Evaluation Brief EB17
Selinda Research Associates, Inc.
August 20, 2008
== DRAFT ==

July 2008 On-Site Testing
of TAT Markers, MT & TAT Waysides, and Time Zero Portal Area

It's About Time:

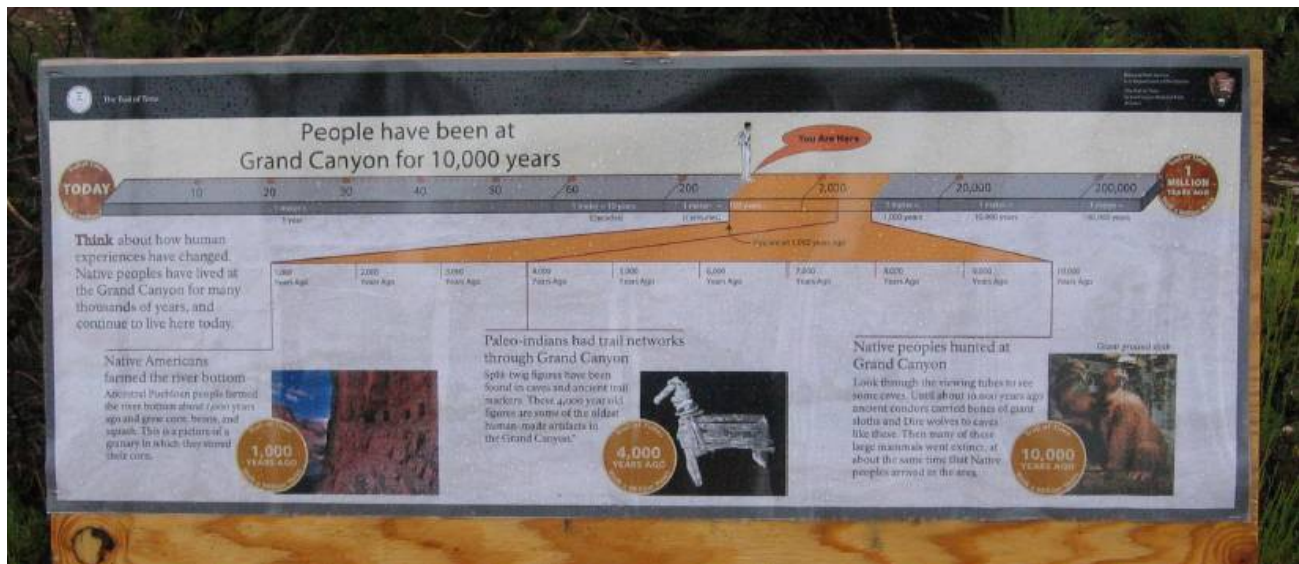
1. Move this panel from 10ya to 20ya. We quickly discovered that the original location (10 meters from the *Temporary Sign*) caused too much congestion at the entrance to the MYT, resulting in many visitors by-passing the *Temporary Sign*, the *It's About Time* wayside, or both.
2. Redesign the panel.
 - a. Put the timeline closer to the bottom and then explain a bit more about it, for example something like the following. (The long rectangle would be similar to the current WIS.)

- b. Add explanatory text : We stretch out time at the beginning so you can find your birthday. We squeeze time down at the end so you can see what happened without walking a million steps. The trail is short enough so you can see all that happened; but long so you can feel how much time has passed

- c. Retain the stack-of-quarters analogy if possible; include a stylized illustration showing a stack of quarters from the bottom to the top of the GC. Suggested text: IMAGINE a million. A stack of 1 million quarters would be as high as the canyon is deep.

- d. Flesh out (slightly) the birthday activity. We found many respondents who experienced a “so what” phenomenon when they didn’t know what they were supposed to do after they found their birthdays. Suggested text: Find your birthday. As you walk the trail, think of all that happened before you were born.

Earthquakes & Volcanoes:

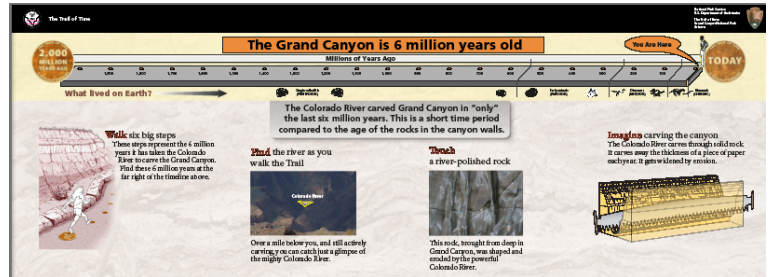
1. Replace the volcano diagram with a similar “graph” as in *Cycles and Climate Change*, but with times of heavy volcanism vs times of quiet..... [Do volcano/earthquake times overlap? If so, the graph can depict “restless times.” If there isn’t a one-to-one correspondence, perhaps have overlapping “graphs” one depicting times of volcanism, and one depicting times of earthquakes.]

2. This wayside is somewhat problematic as (a) it’s not clear what the point is, and (b) it tended to reinforce visitors’ misconception that the GC was formed from big events like volcanoes and earthquakes (and glaciers!) The challenge here is that visitors overwhelmingly want to know what created the canyon. How do we convey the relatively minor role volcanoes and earthquakes have played at least compared to the river.

3. Heading/title: 200,000 years ago volcanoes and earthquakes were active in the area.
4. Some respondents tried to look in the hunk of basalt for pottery shards. We’re not sure what to recommend here. It would be a shame to lose this as it makes a nice human connection, and brings it back to a human time scale.

5. Remove the “Find the volcanic rocks” as some respondents started looking around on the ground.
6. There wasn’t very much for visitors to have a conversation about at this wayside. Is there a way to more directly connect three time scales: years, centuries, millennium and beyond?

Canyon Carving:

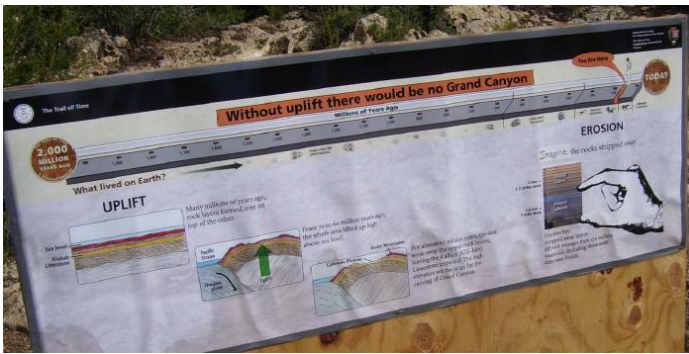
1. Heading/title: 6 million years ago the Colorado River began carving the Grand Canyon.
2. Remove the photo/text related to "Find the River" You can't see the river from here. Replace this with a viewing tube along the MYT as described previously.
3. Move "Walk six big steps..." to the right of the panel which is where someone would do it. Put "Touch a river-polished rock..." to the far left (and the rock there too), "Imagine carving the canyon..." in the middle. Alternatively, put the river-polished rock in the middle and "Imagine canyon carving" to the left.
4. Label the rock: River-polished rock. Remove the reference to basement rock as some respondents mistakenly thought that "basement rock is 6 million years old."

Uplift & Erosion:

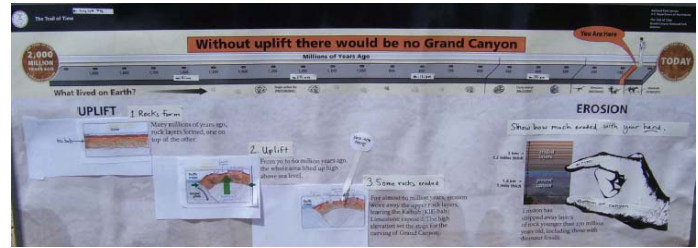
- Consider making this panel into two waysides, one at 60 million years ago and talking about erosion; one at 70 million years ago and talking about uplift.

- Heading/title: 70 million years ago this area was at sea level.
- Keep the text: Without uplift there would be no Grand Canyon. This sentence grabbed respondents' attention.
- For the first time many respondents were able to use the diagram to understand the concept of uplift and its role in the formation of the Grand Canyon. Content-check the three-step diagram and accompanying text – and tweak it, without making major revisions or adding complexity.
- Consider adding a 3-D map of the western United States with the Rocky Mountains, Colorado Plateau, and the Colorado River from its source to its sink.
- Test the new panel with visitors at the rim.

- Heading/title: 60 million years ago the dinosaur fossils started to disappear.
- Make the single diagram into a two- or three-step photo/diagram. We found that some visitors became confused with the single photo/diagram, either using two hands, and/or holding their hand up to the panel rather than the canyon, etc.
